Department of Planning and Zoning

TO: Development Review Board
FROM: Scott Gustin *AD*
DATE: December 17, 2013
RE: 14-0591CA/CU; 250 North Winooski Ave

Request: Construct front addition to existing automotive service and repair business.

EXHIBIT C
BUILDING ELEVATIONS

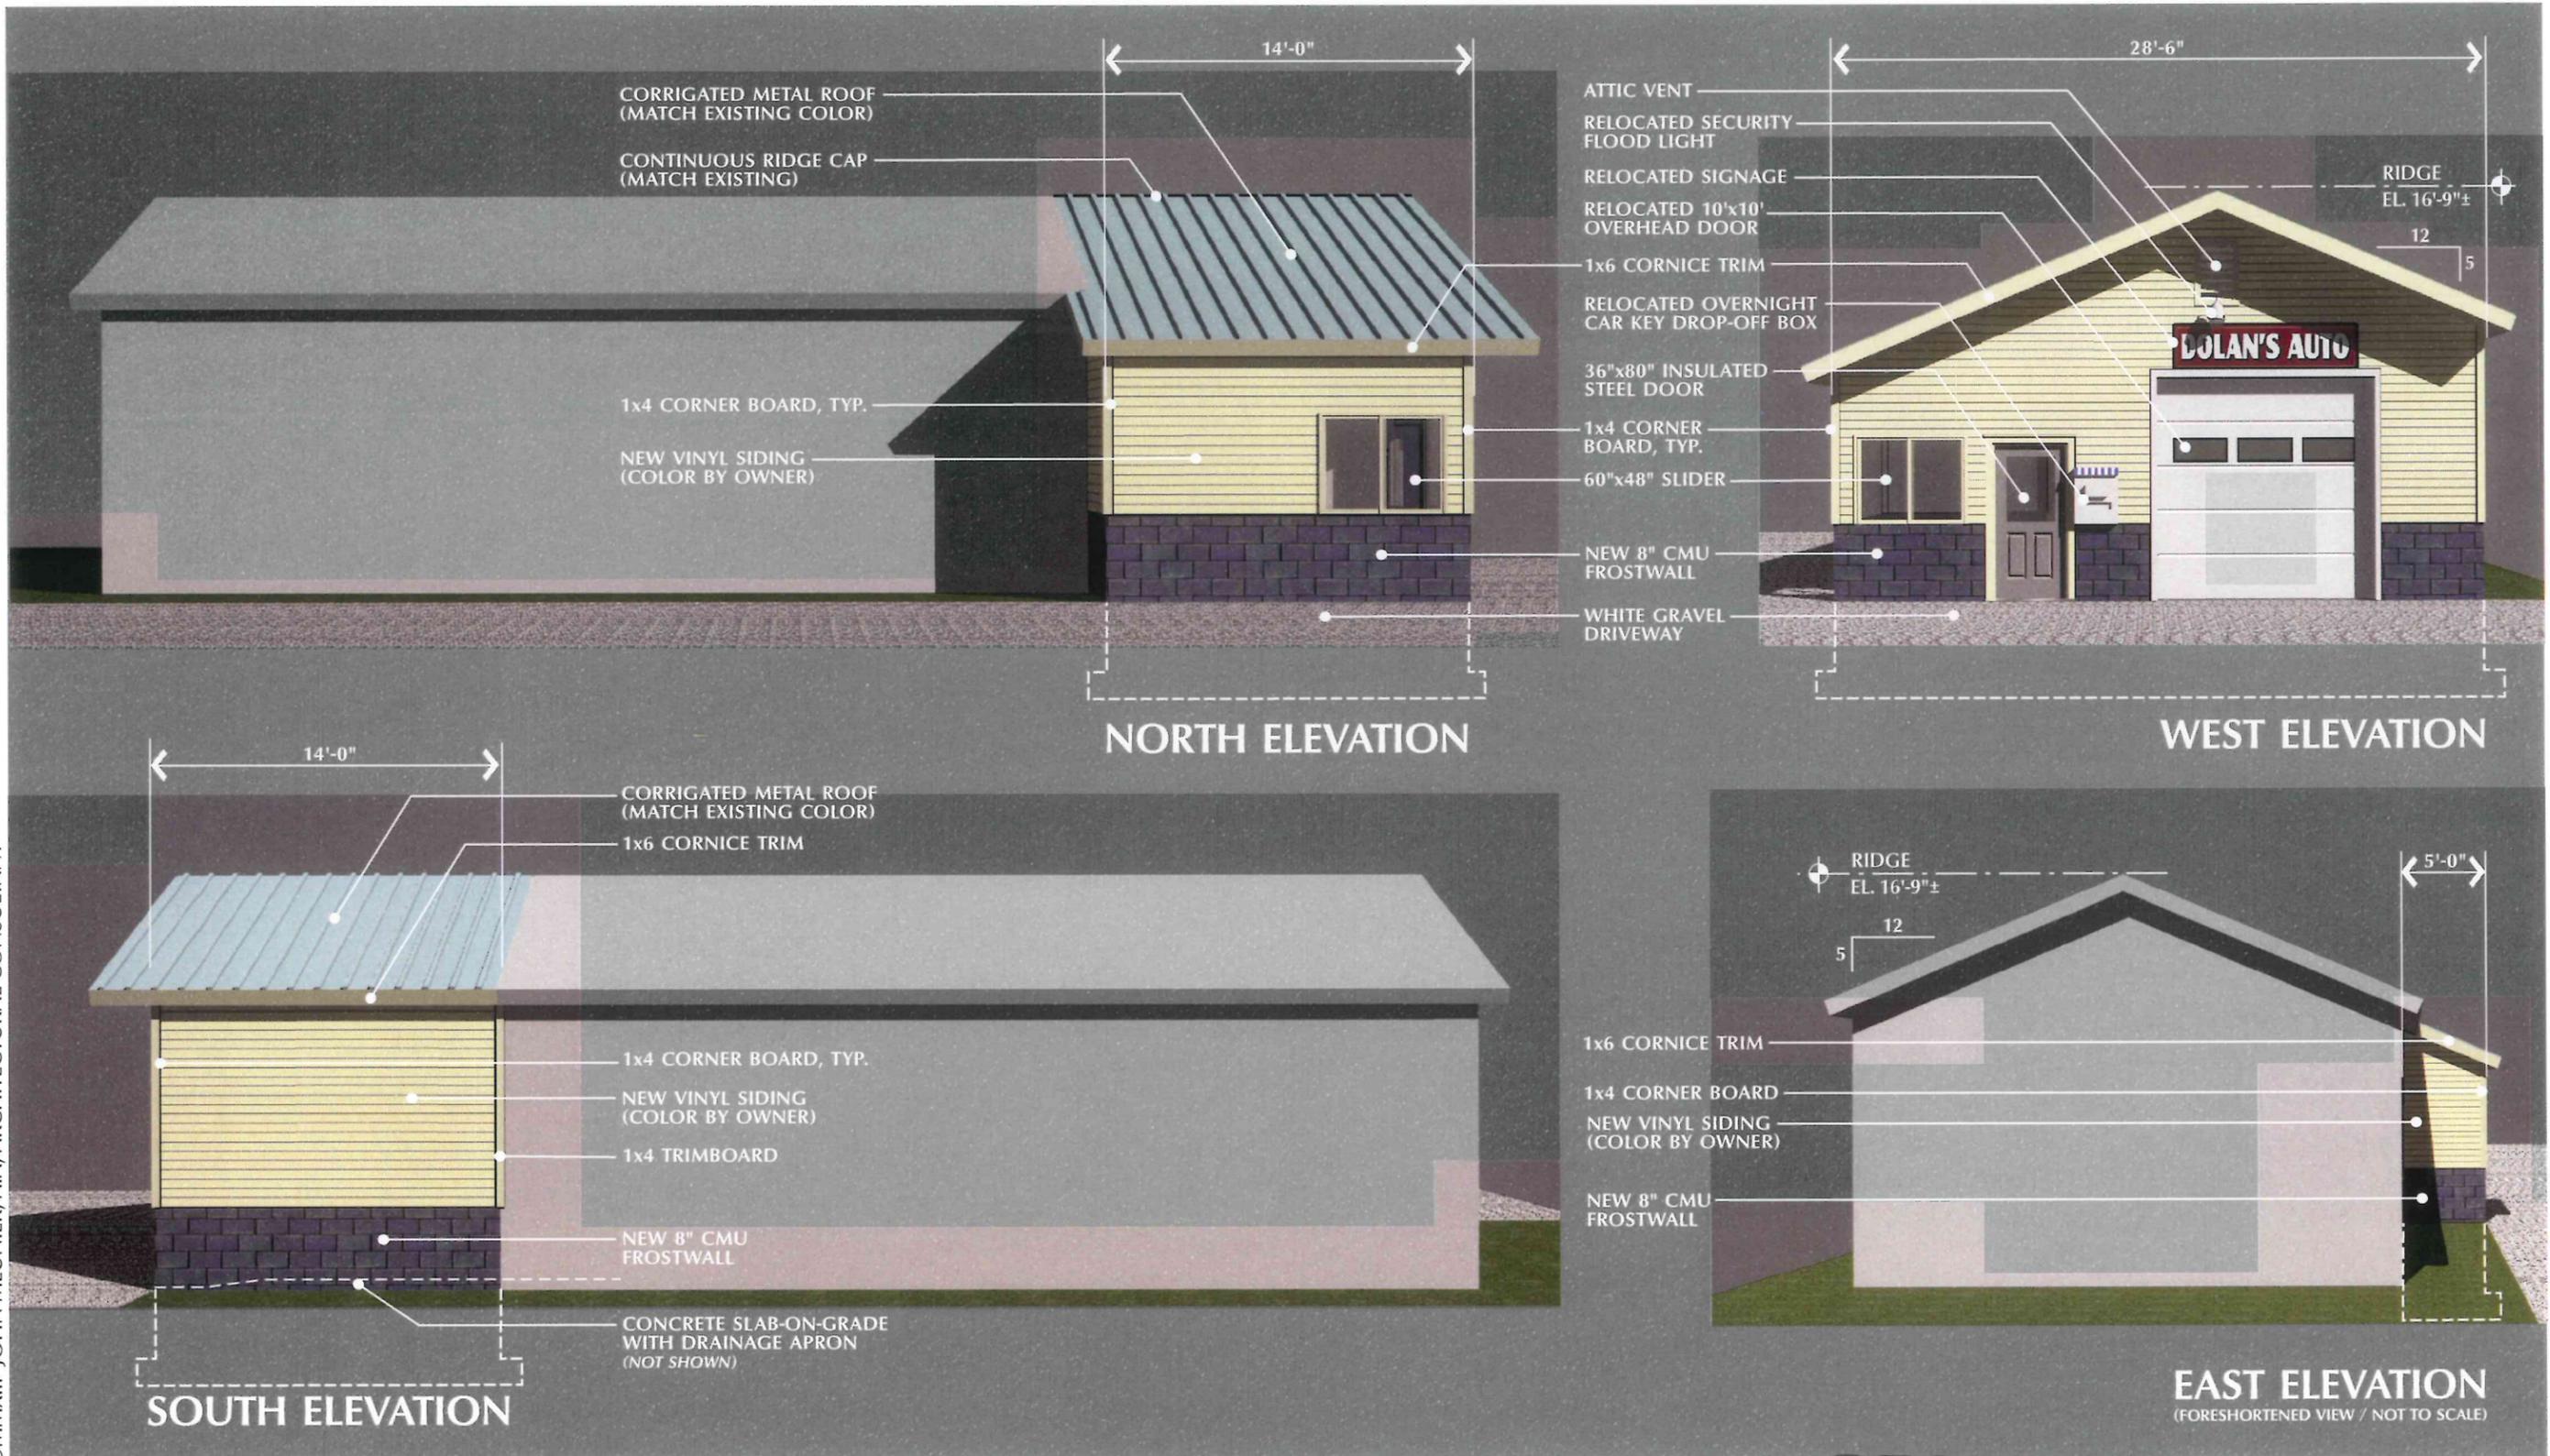
The proposed addition will share a gable roof of the same slope as the existing garage. **(Affirmative finding)**

New window openings are limited and basic in appearance. Two new windows, a pedestrian door, and an overhead door are proposed. Their placement and appearance are consistent with the utilitarian nature of the garage. **(Affirmative finding)**

The garage is currently clad in T-111 siding and standing seam metal roofing. The addition will be clad in vinyl siding. The new siding will be applied on the entire structure to replace the T-111 as well. Standing seam roofing will be installed on the addition to match the existing roofing. These materials are acceptable for this application. **(Affirmative finding)**
